KP-NRC-2401-001

Enclosure 1
Changes to Hermes 2 PSAR Chapters 4, 5, 7, and 13
(Non-Proprietary)

Figure 7.1-1: Instrumentation and Controls System Architecture

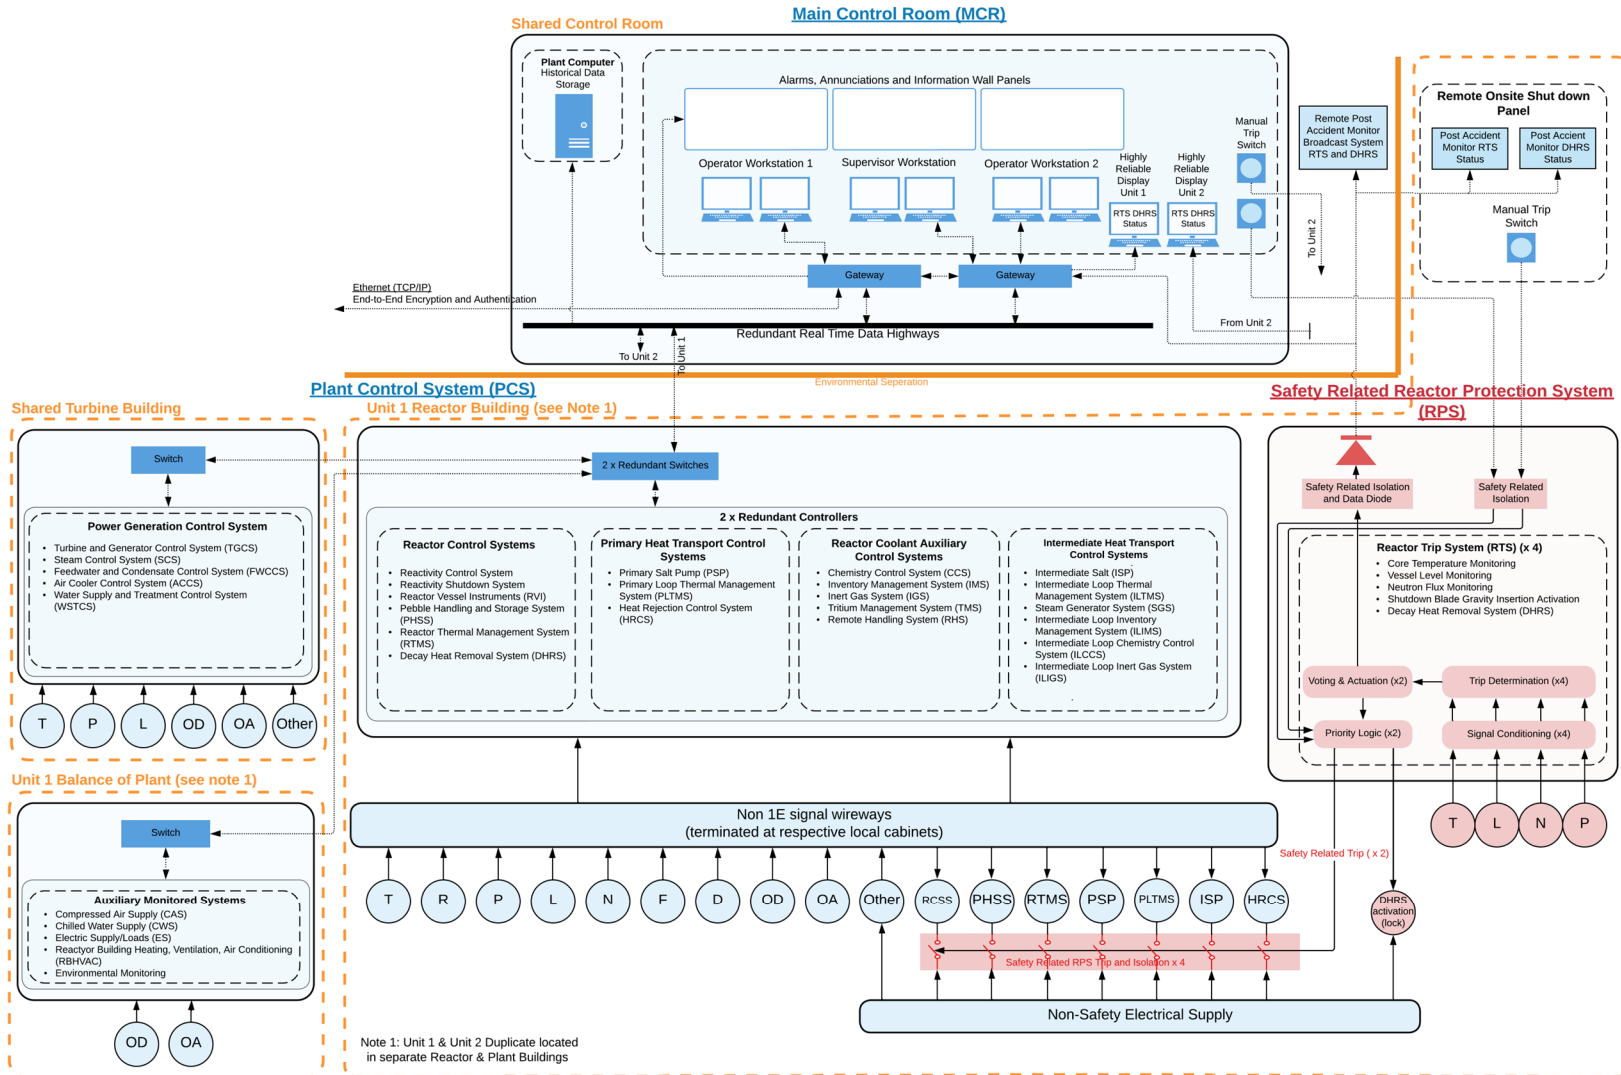
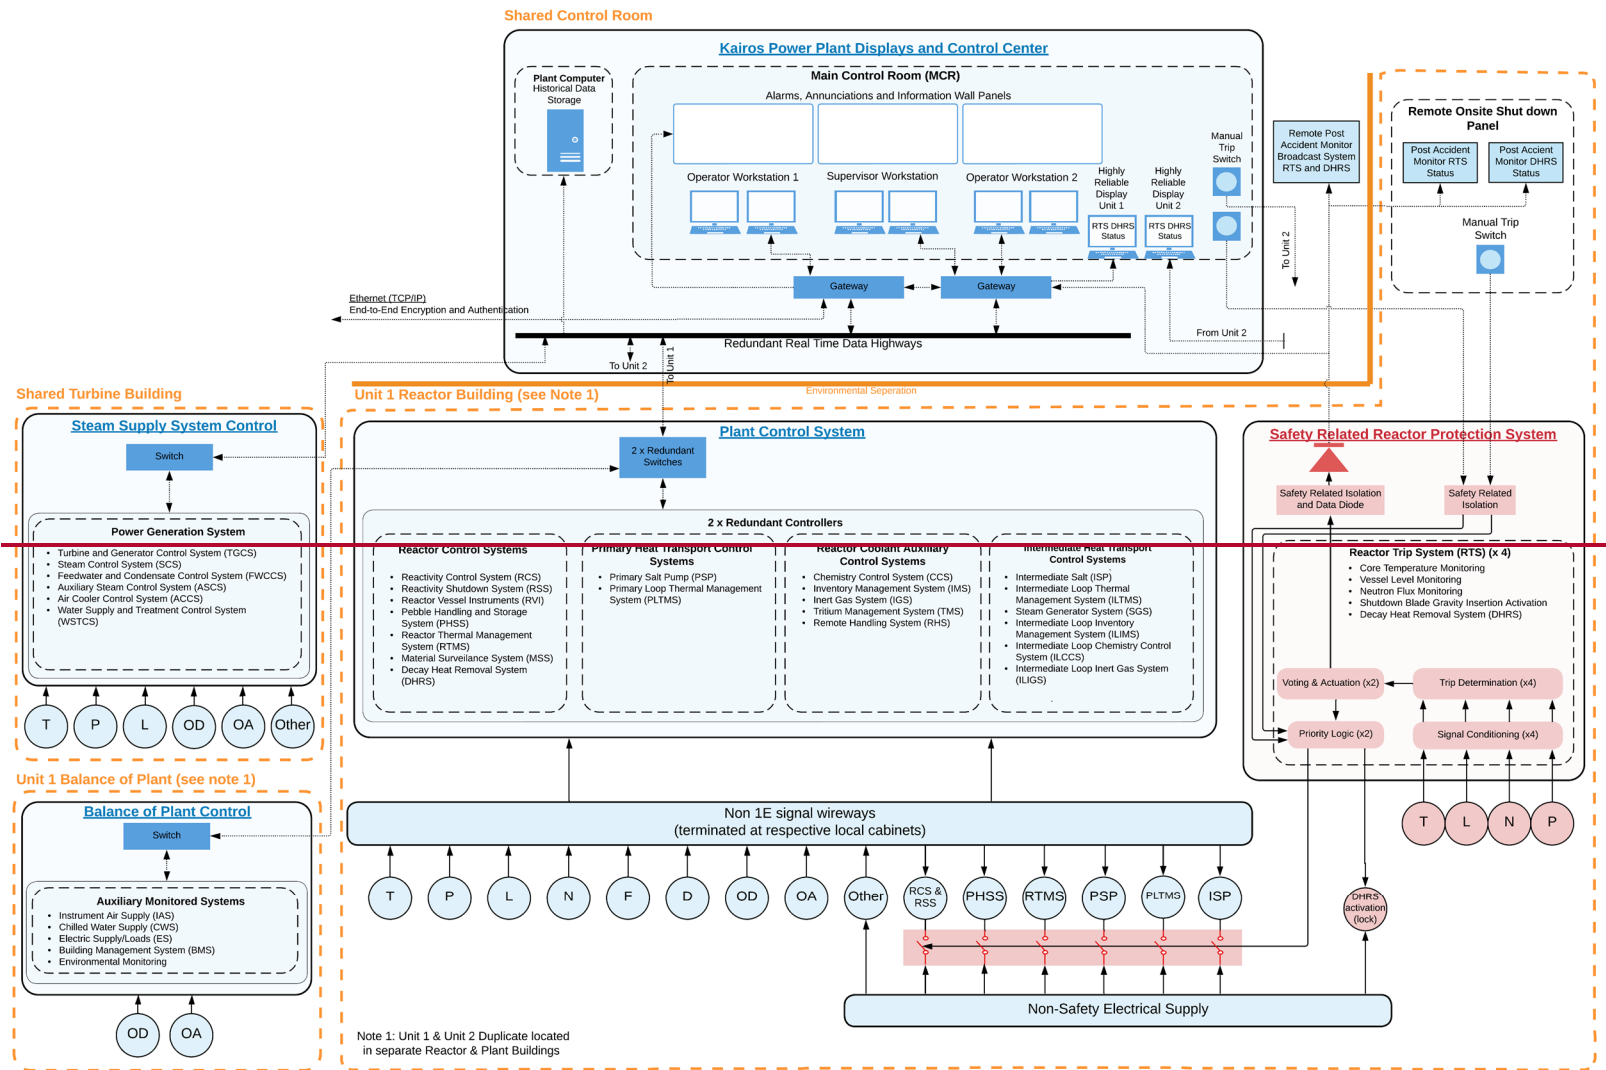
The PCS is a non-safety related control system which controls reactor startup, changes in power levels, [reactor shutdown, heat transport, and power generation system](#). The PCS implements these functions through a series of subsystems which include:

- Reactor control system (RCS)
- Reactor coolant auxiliary control system (RCACS)
- Primary heat transport control system (PHTCS)
- [Intermediate heat transport control system \(IHTCS\)](#)
- [Power generation control system](#)
- [Auxiliary monitored systems](#)

This allows the PCS to maintain plant and unit parameters within the normal operating envelope. The RCS, RCACS, PHTCS, and IHTCS are unit-specific subsystems. The power generation control system is shared between Unit 1 and Unit 2. [The auxiliary monitored systems are unit-specific](#). The PCS also provides data to the control consoles located in the main control room (see Section 7.4). Figure 7.1-1 shows the elements of the PCS.

The power generation control system controls and monitors systems and components that support normal operation of the turbine-generator which converts heat from the intermediate loop into electrical power. The system includes five subsystems, as shown on Figure 7.1-1, which supports the control and monitoring of ~~following the following capabilities:~~

- ~~Monitoring of turbine~~ Turbine-generator system parameters and initiation of turbine-generator trips, ~~and pump runbacks,~~ position of turbine control, and bypass valves
- ~~Control of steam~~ Steam system flow rate from each unit's superheater to the turbine, and auxiliary steam loads
- ~~Control of condensate~~ Condensate and feedwater system flow rate and temperature to the evaporator
- ~~Control of the position of turbine control and bypass valves~~
- ~~Control of the removal~~ Removal of heat from the air-cooled condenser
- Makeup water supplied to the condensate and feedwater system; and blowdown to the drains
